1. Comment [r01-462](#) - Updating Figure 145-22 page 168 line 35, Figure 145-31 page 207 line 22 to sync with proposed text in comments [r01-286](#), [r01-287](#).
2. Addressing comment [r01-378](#) regarding the need to split Rsource_min/max to Rsource1_min, Rsource2_min and Rsource1_max, Rsource2_max for setting the correct PSE voltage at the PSE PI to allow adjusting Vsource to get VPort_PSE-2P at the PSI PI. [This comment is addressed in a simpler way.](#)

Per the latest changes we did to include equipment connector in the PSE PI and in the PD PI for unbalance tests the following changes should be made:

1. *Change the title of Figure 145-22 from:*

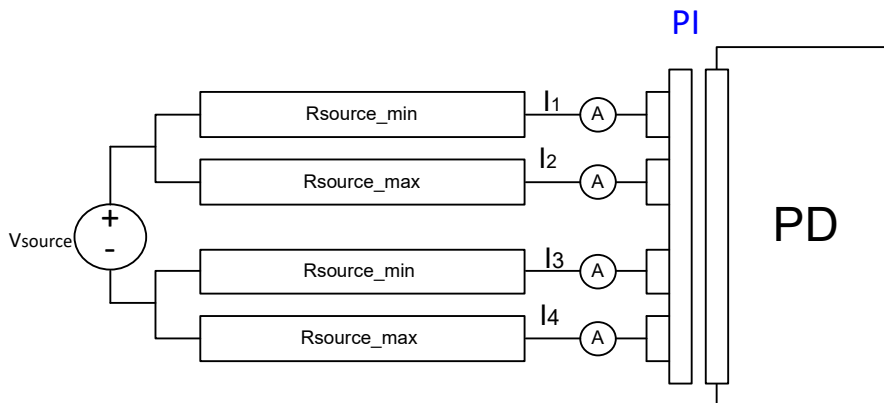
- a) Figure 145-22, the borders of the test verification model need to be clearly shown.
- b) Figure 145-31 and NOTE 1 in line 33 need similar adjustments.

"Figure 145-22—PSE PI unbalance specification and system resistance unbalance"

To:

"Figure 145-22—PSE current unbalance verification circuit"

2. *Change figure 145-31 as follows:*

3. *Change the title of Figure 145-31 from:*

"Figure 145-31—Icon-2P_unb and lunbalance evaluation model"

To:

"Figure 145-31—PD current unbalance verification circuit"

5. *Delete Note 1* ("OTE 1—Rsource includes the connector resistance at the PD PI, for which the maximum recommended value is 20 mΩ per contact.)

NOTE 2—The pairset current limits [requirement also holds](#) ~~should also be met~~ when Rsource_max and Rsource_min are ~~swapped~~ [exchanged](#) ~~between pairs of the same polarity.~~
